CERTIFICATE OF APPROPRIATENESS

Property: 501 Highland Street, lot 16, block 9, Woodland Heights Subdivision. The property includes a historic 1,654 square foot two story residence and two story garage-apartment situated on a 5,000 square foot (50' x 100') corner lot.

Proposal: Alteration – Revision. The applicant submitted a COA application for an addition to 501 Highland Street that was considered at the February 26, 2015 HAHC meeting. This proposal involved constructing a two-story addition, replacing the previously existing stucco cladding, and lifting the residence by 11” to install a new foundation. Staff found that the application to not meet criteria 1, 4, 8, and 9 for alterations to Contributing structures. Among the concerns cited, staff found that the addition would be visually incompatible with the smaller existing residence, compounded by the fact that the property is on a corner lot with greater visibility. The proposed lifting of the residence would destroy the front porch and masonry chimney while the house’s original structural shiplap has been removed and destroyed.

PROPOSED LOCATIONS OF DELETED STEPS

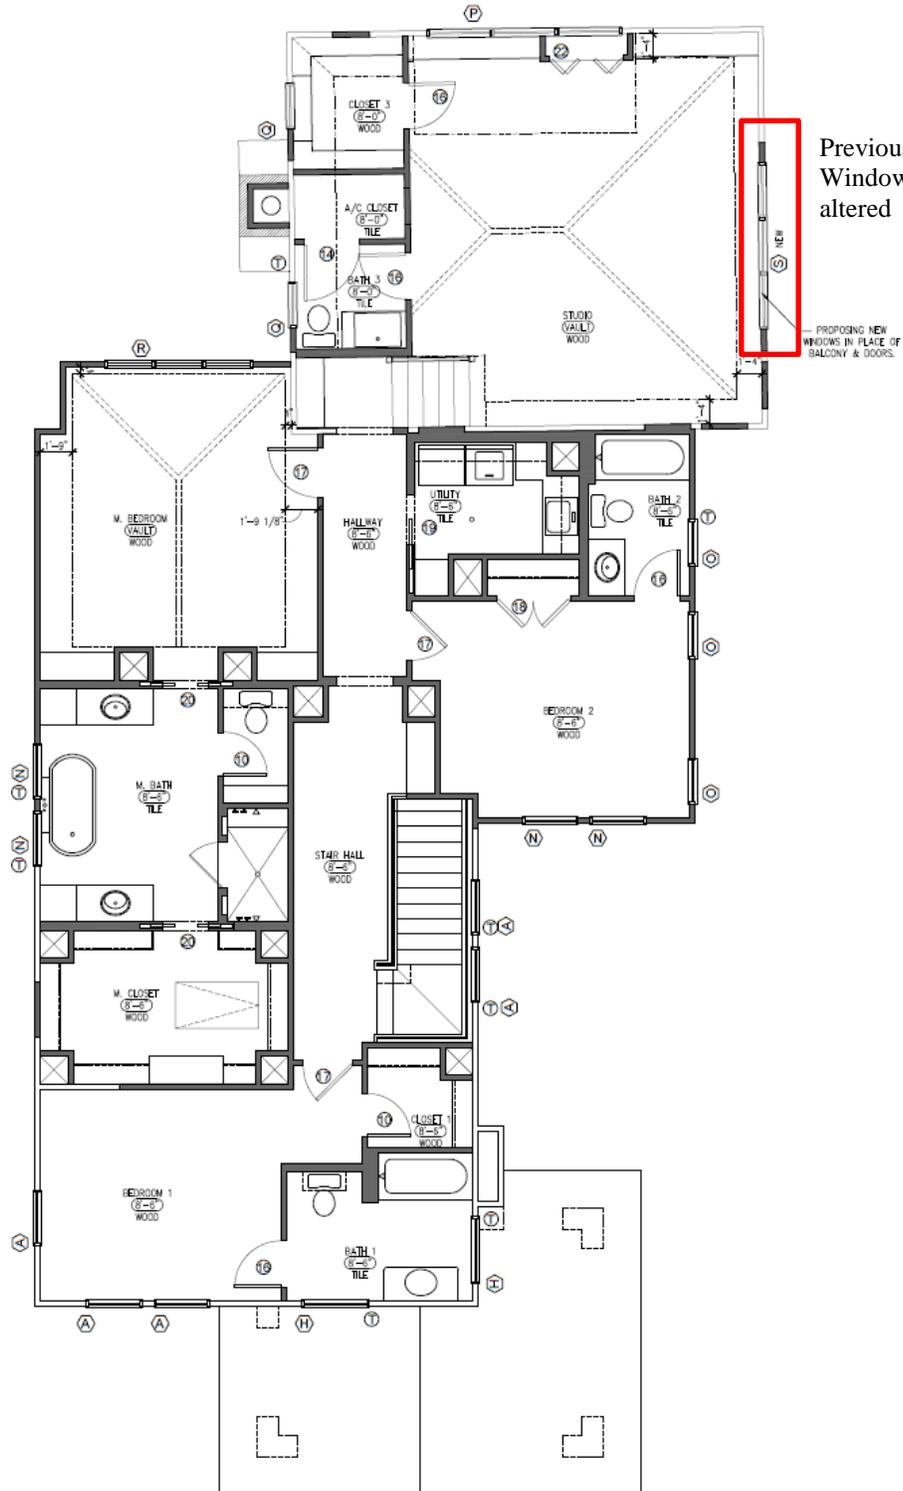
- Delete a proposed second set of steps from the front porch as well as a set of steps leading from the family room to the back patio.
- Delete the proposed small balcony, set of doors, and two windows on the second floor of the garage facing Helen Street, and replace with three aluminum clad windows.
- Extend the previously approved set of steps at the kitchen, and extend the corresponding roof overhang an additional 3’
- Change the roofing material on the new front porch, kitchen step overhang, and rear garage dormer from asphalt shingle to metal

Shape/Mass: February 2016: The applicant now proposes to delete a formerly proposed second set of steps from the front porch (facing the rear) as well as a set of steps leading from the family room to the back patio. The applicant also proposes to delete the small balcony, set of doors, and two windows on the second floor of the garage facing Helen Street, and replace with three aluminum clad windows. The two outer windows will be operable casement windows and the middle will be one fixed window. The previously approved set of steps at the kitchen, and extend the corresponding roof overhang an additional 3'-0". See drawings for more detail.

ROOF MATERIAL ALTERATIONS

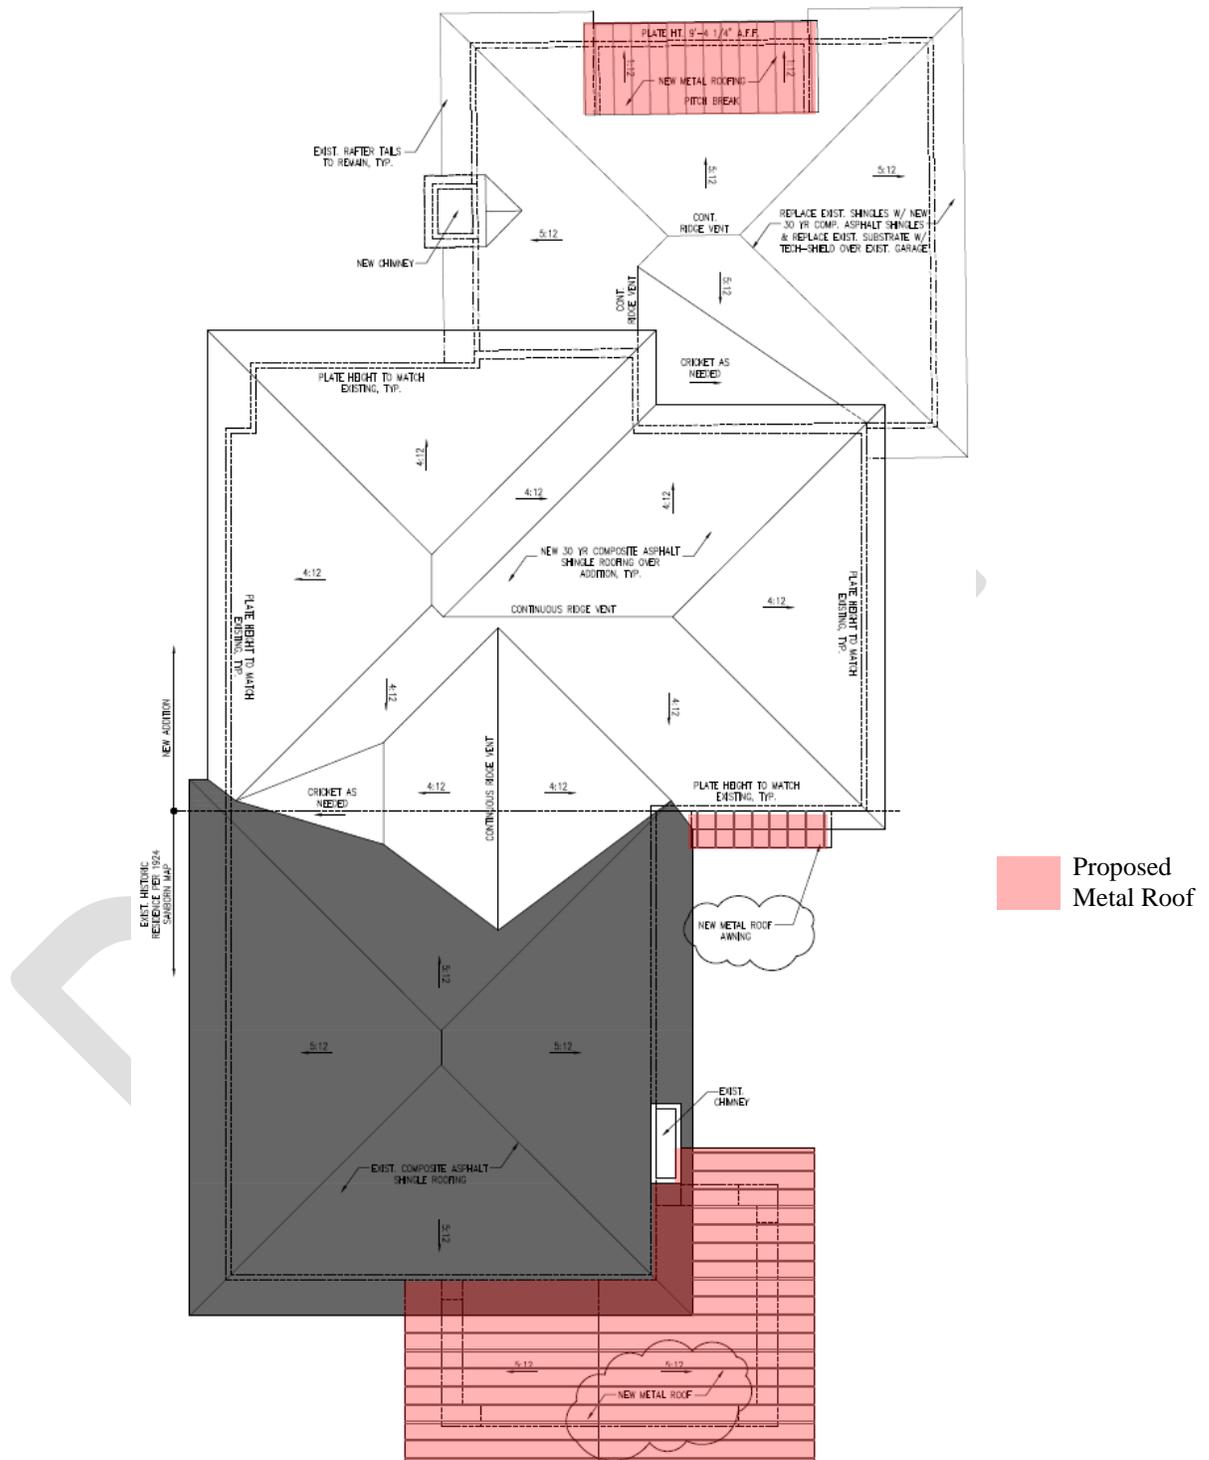
Roof February 2016: The applicant proposes to change the previously approved composition shingle roofing material on the new front porch, kitchen step overhang, and garage dormer to metal roofing. See drawings for more detail.
